Dyno Nobel Ammonium Nitrate Plant

Supplementary Report for the
proposed Moranbah Ammonium
Nitrate Project

Responses to issues raised

December 2006

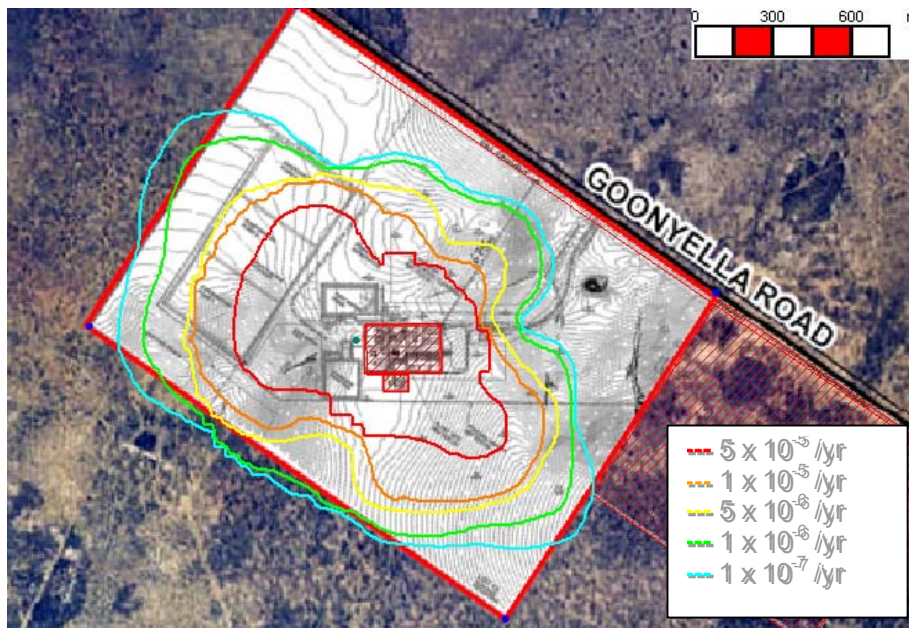
OR12 - Fatality Probit Basis: The fatality limit for overpressure was set at 21kPa, which corresponds to 10% chance of fatality. In QRAs involving fatality analysis we would normally use the 1% fatality probit distance as a cut-off, and its use would undoubtedly result in larger risk contours. In fact there is a significant difference in the fatality probit that applies to "within buildings" compared with "in the open". However, GHD used 21kPa overpressure to screen out the lesser fatality events (ie on the assumption less than 21kPa at the boundary equalled "no offsite fatalities"). This is far too optimistic, particularly where off-site effects could be on people within buildings, and it could have an effect on the risk contours (which could currently be significantly underestimated).

Considering the 1% outdoor fatality rate at 14kPa – the distance of impact from the explosion (3,000 tonne at 32% NEQ) is 840m, compared to 21kPa (10% fatality), which reaches 630m. The site boundary is 640m away from the 3,000 tonne storage facility.

A typical industry frequency for an AN Prill explosion from a shipping container is in the order of 1×10^{-6} /yr, therefore the risk at 840m is 1×10^{-8} /yr and at 630m it is 1×10^{-7} /yr. This will have negligible impact on the risk contour below. Therefore, the current criteria for overpressure contours will be maintained.
